Access Compliance Report

Public Rights-of-Way

Intersection ID: 46303	Main Street: HONEY_CREEK_LN	Cross Street: MERMANS_RD	Location:	NE
ADA ID: 0A9D48947FAD	Ramp Type: PerpDiag	Initial Pass/Fail: Fail	Overall Compliance: No	Severity Score: 10
Codes/Mitigation Info/Possible Solution		Field Measurements/Component Compliance

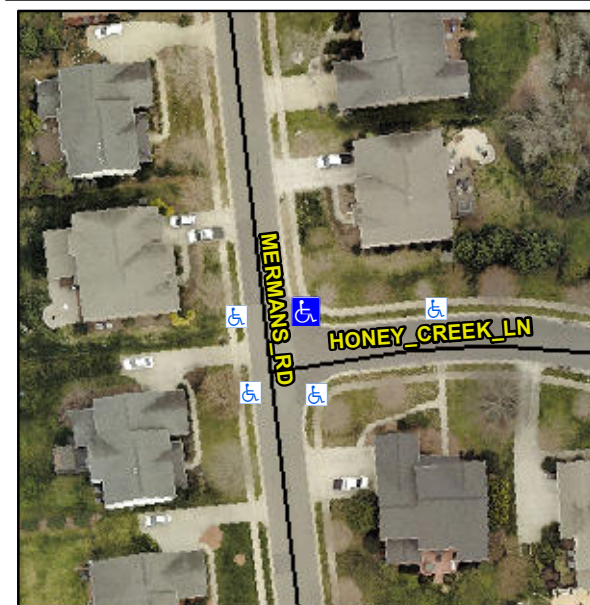
Not Found, R304.5.1, R304.5.3

Compliance	Description	Data	Compliance	Description	Data
N/A	Ramp Length (in)	48.0	Yes	Ramp Slope (%)	5.4
No	Ramp Width (in)	40.0	No	Ramp XSlope (%)	3.1
N/A	Flare Type LT	N/A	N/A	Flare Type RT	N/A
N/A	Flare Slope LT (%)	N/A	N/A	Flare Slope RT (%)	N/A
N/A	Flare Traversable LT?	N/A	N/A	Flare Traversable RT?	N/A
N/A	Landing Length (in)	N/A	N/A	DWS Provided?	N/A
N/A	Landing Width (in)	N/A	N/A	DWS Contrast?	N/A
N/A	Landing Slope (%)	N/A	N/A	DWS Length (in)	N/A
N/A	Landing X Slope (%)	N/A	N/A	DWS Full Width?	N/A
N/A	Landing Curb? (Y/N)	N/A	N/A	DWS Offset (in)	N/A
N/A	Shared Landing?	N/A			
N/A	Gutter Ponding?	N/A	N/A	Gutter Slope (%)	N/A
N/A	Gutter Lip Ht (in)	N/A	N/A	Gutter X Slope (%)	N/A
N/A	Painted X Walk1?	No	N/A	Painted X Walk2?	No
	X Walk 1 Direction	To W		X Walk 2 Direction	To S
N/A	X Walk 1 Width (in)	N/A	N/A	X Walk 2 Width (in)	N/A
	X Walk 1 Slope (%)	4.6		X Walk 2 Slope (%)	0.0
	X Walk 1 X Slope (%)	0.7		X Walk 2 X Slope (%)	3.7

Remove & Replace Curb Ramp With Two New Directional Ramps or Equivalent.
